SG/GK  
14274  
26 June 2017

**S75W Modification Application - CENTRAL PARK CONCEPT PLAN – MOD 13  
ENVIRONMENTAL ASSESSMENT REPORT  
MP 06\_0171 (MOD 13)**

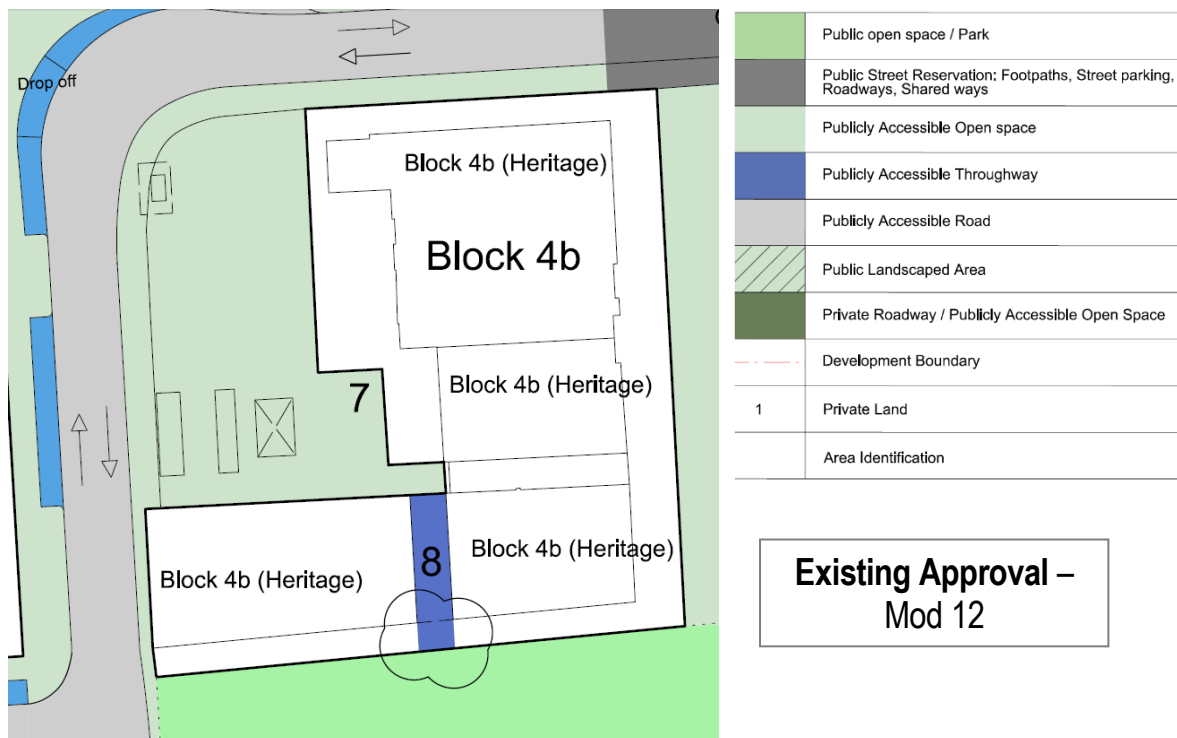
**Figure 1** below illustrates the proposed amendments to the public domain plan of the Concept Plan drawings (when compared to the current approved plan). It is noted that there is no change proposed to the 'non-residential' land use, as identified for the site in the current Concept Plan approval. Furthermore, no change to the GFA is proposed as a result of this amendment.

The proposal seeks to amend a portion of the area to the west of the Brewery Building from 'Publicly Accessible Open space' to 'Private Roadway / Publicly Accessible Open Space', in a similar way to Park Lane (Blocks 5A, 5B and 5C) and the recently determined Block 11 building.
